Permit #: BLD-2012-0013
Issue date: 01/25/2012
Expire date: 07/23/2013

Permit Type: Single Family Alteration/Repair Permit
Project:

Remarks: Deck at front of house.

From: Ingalls, Paul
Sent: Wednesday, January 18, 2012 3:57 PM
To: 'macready68@hotmail.com'
Subject: Deck Permit
Attachments: 20120118154853104.pdf

CARRIE MACREADY
1901 24th STREET
"PLAYGROUND"
SCALE 1/4" = 1 FT

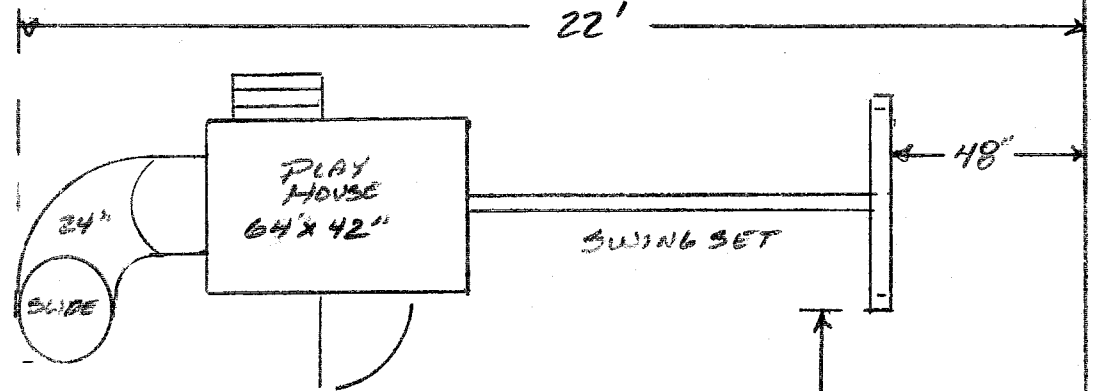
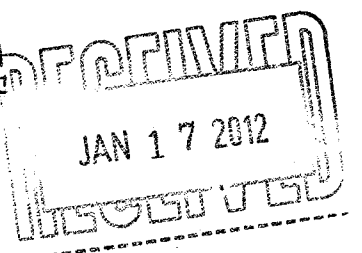
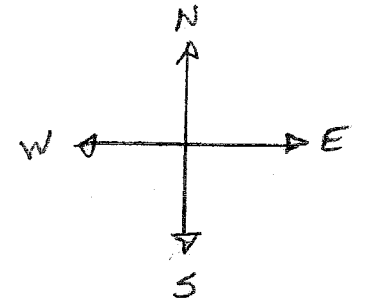
1. Are the 1x4 and 2x4 on the existing concrete porch preservative treated?
2. The front property line is not identified on the site plan. I have attached a copy of the City Map showing the property lines, buildings etc. The house is somewhere between 25 and 27 feet from the front property line.
3. According to the measurements on your site plan the fence is encroaching in the 24th Street Right of Way. When was this constructed?

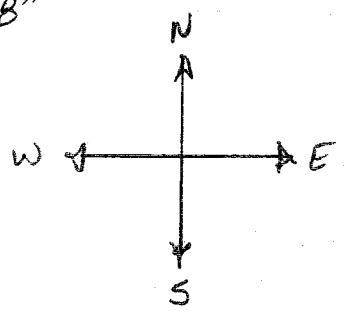
Front property
line

25 feet
